## DG306/126 pin Amendment Notice

Amendment Items: DG306/126 pins improvement.

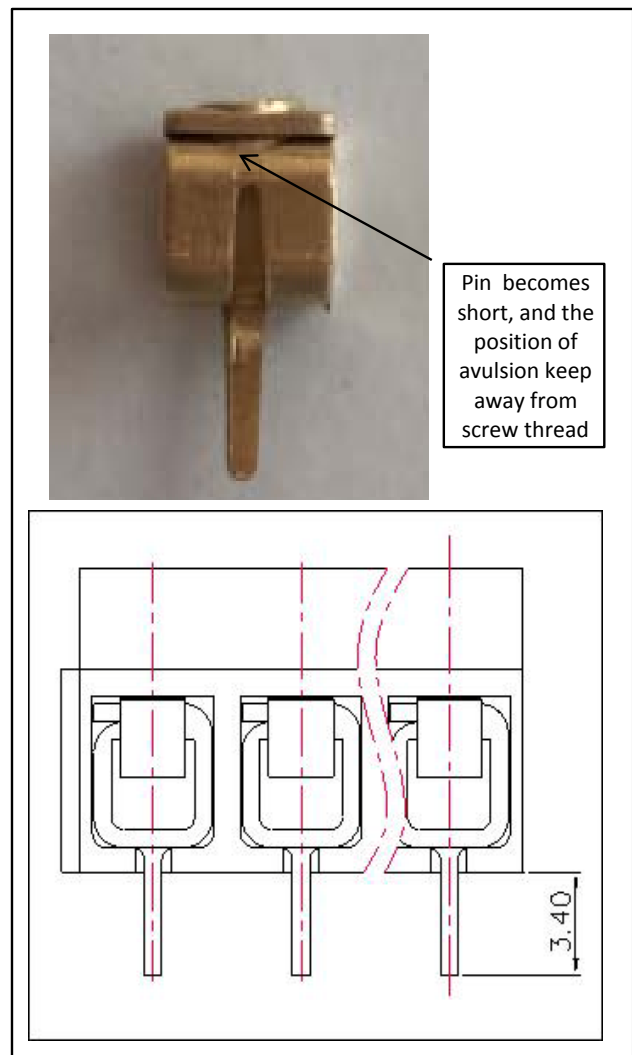
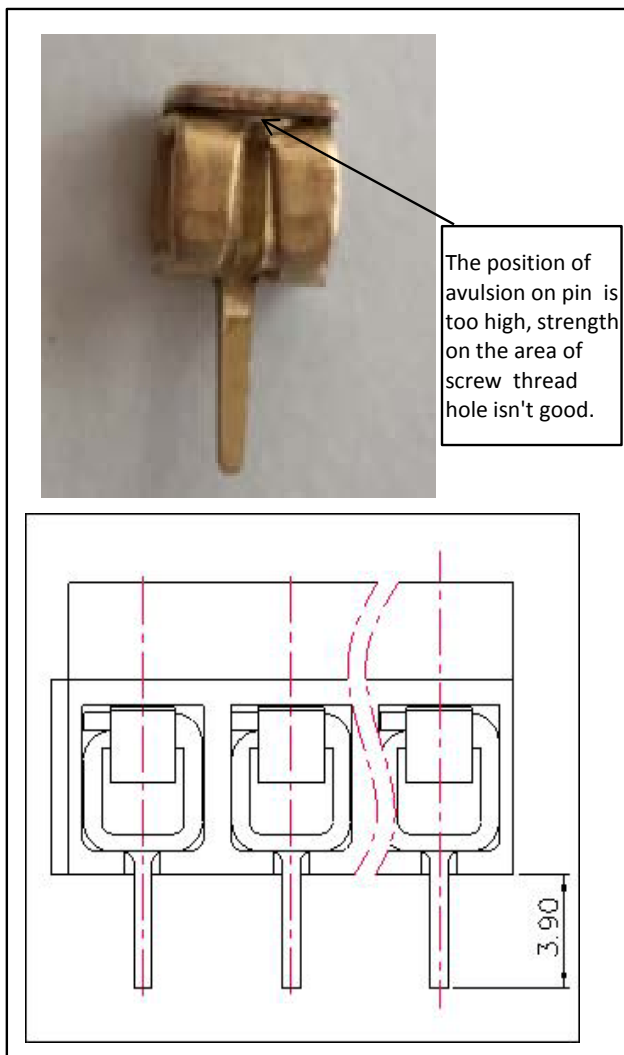
**Explanations:** After assessment of our R&D Dept, the position of avulsion on pin is too high, so the strength on the area of screw thread hole isn't good. Now we shorten pin, the position of avulsion keeps away from screw thread hole, it's easy for molding in process of stamping bending, in addition, it can improve product strength and keep product property more stable. It's OK that we test the products with shortening pins, the exposure pin length of former product is 3.90mm, it's 3.40mm after change.
